**Re: Request for Pre-Application Review  
15 Old Danbury Road, Wilton, Connecticut  
*Requesting Parties:* CD Station LLC (Owner) & Toll Brothers, Inc. (Contract Purchaser)**

15 OLD DANBURY RD | 03/01/24 | BASEMENT FLOOR PLAN | SD1.00

**Re: Responses to October 2023 Pre-Application Feedback**  
**Property: 15 Old Danbury Road, Wilton**  
**Parties: CD Station LLC (Owner)**  
**Toll Brothers, Inc. (Contract Purchaser)**

1 SITE SECTION @ HIGH POINT OF DANBURY RD  
SD3.10 1" = 20'-0"

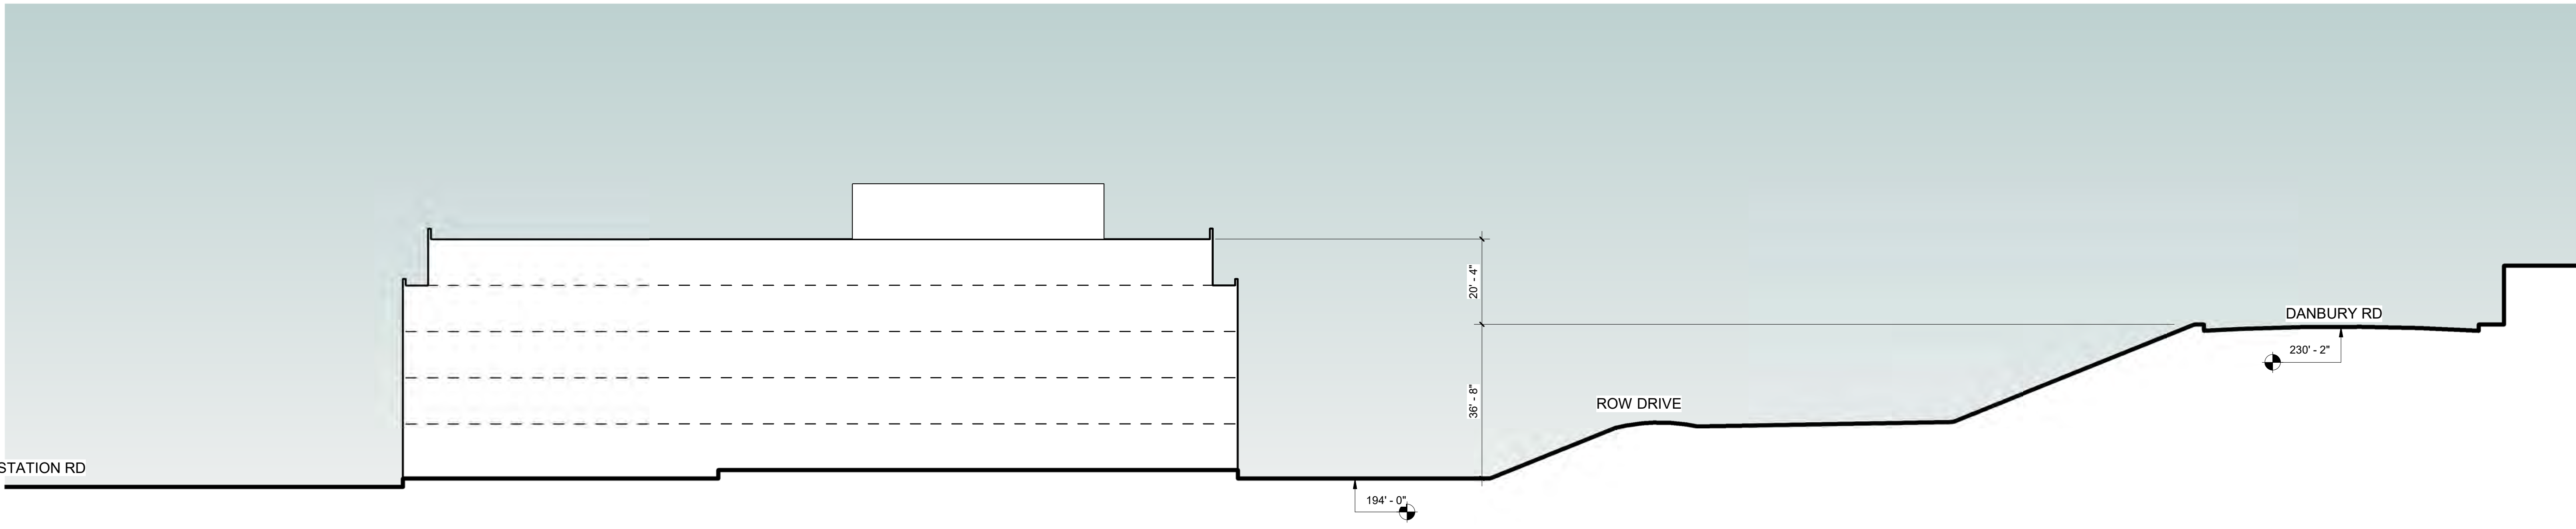
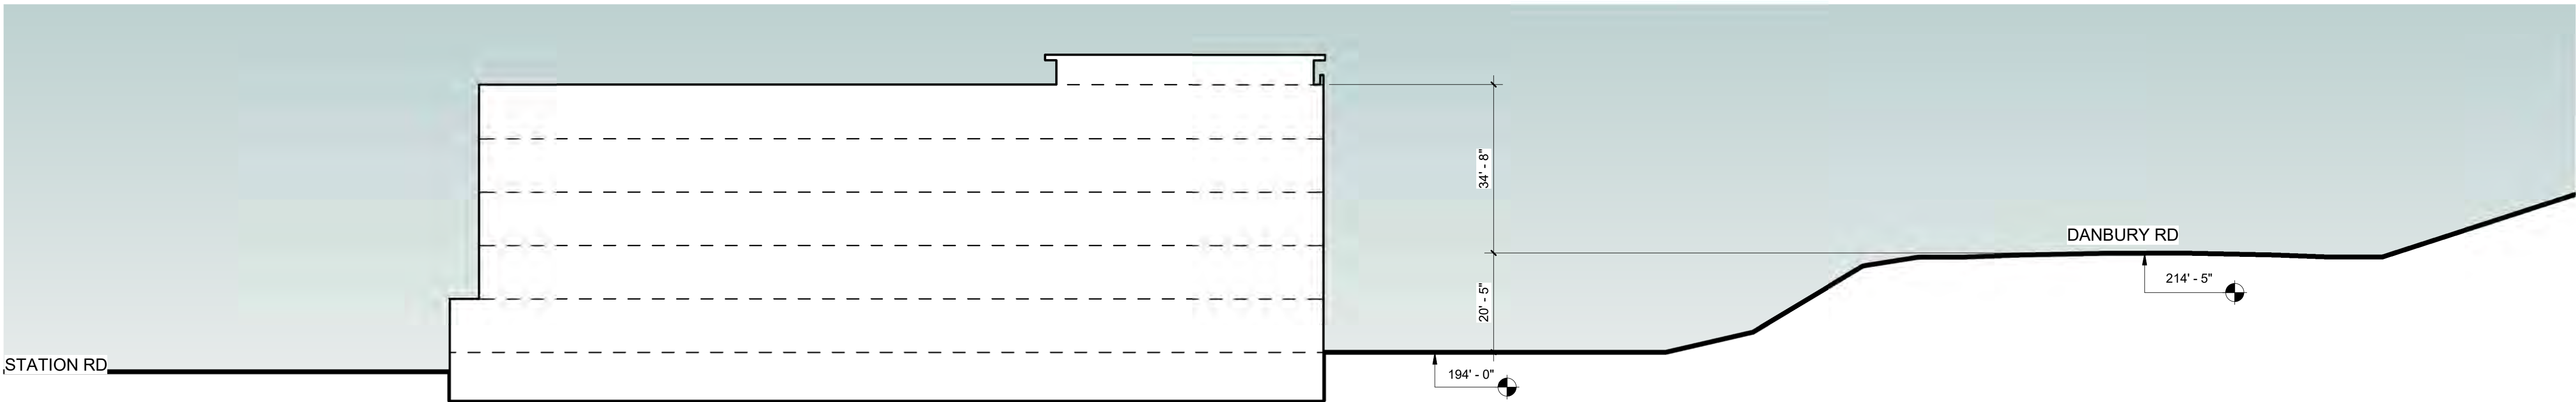
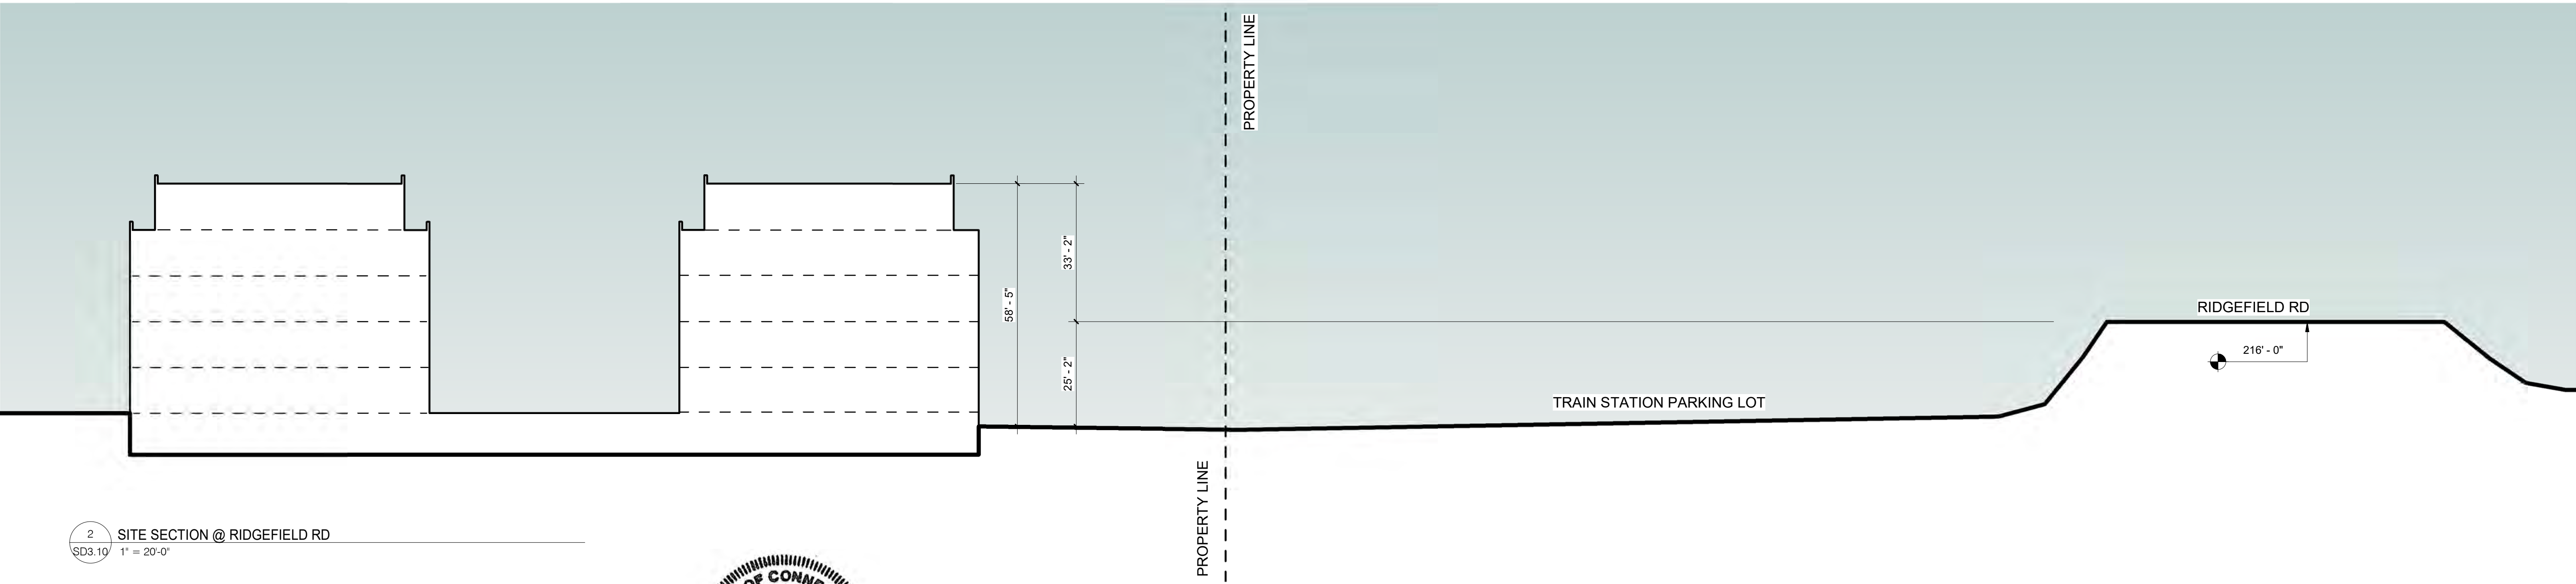
7. Incorporate additional vertical interest to the fifth story.

*The previous design featured a consistent roofline atop the fifth story. By splitting the building into two distinct structures and following the natural grade of the site, the upper roof lines on the project are clearly different. The upper portion of the buildings are further modulated by a stepped building approach in Building B and the setback fifth floor at varying locations on both Buildings A and B. Although the details of these features require future refinement, the addition of architectural elements such as sunscreens, a rooftop pergola structure, and a Wilton sign will all provide detail interest at the fifth floor. The one-story glass amenity space with a pitched roof also serves to break up the vertical plane of the project.*
